Access Compliance Report

Public Rights-of-Way

Intersection ID: 10034415	Main Street: PIERSON_DR	Cross Street: N/A	Location:	E
ADA ID: 52790ABFC0DC	Ramp Type: BlendTrans1	Initial Pass/Fail: Pass	Overall Compliance: No	Severity Score: 0

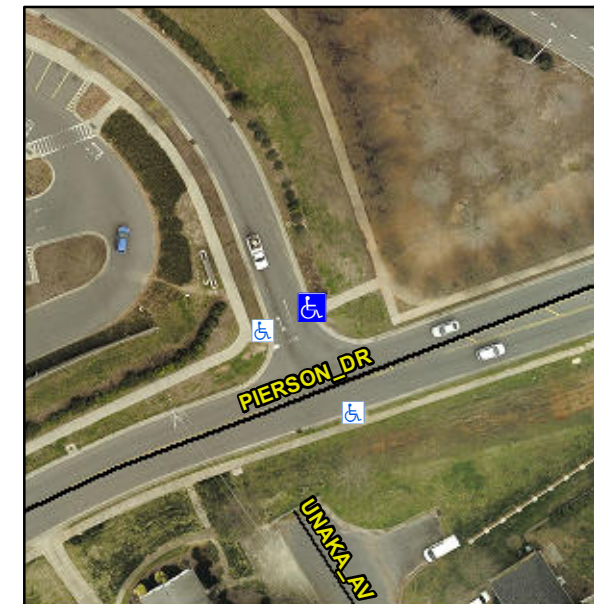
R304.2.2-Perp, R304.3.2-Para

Remove & Replace Landing.
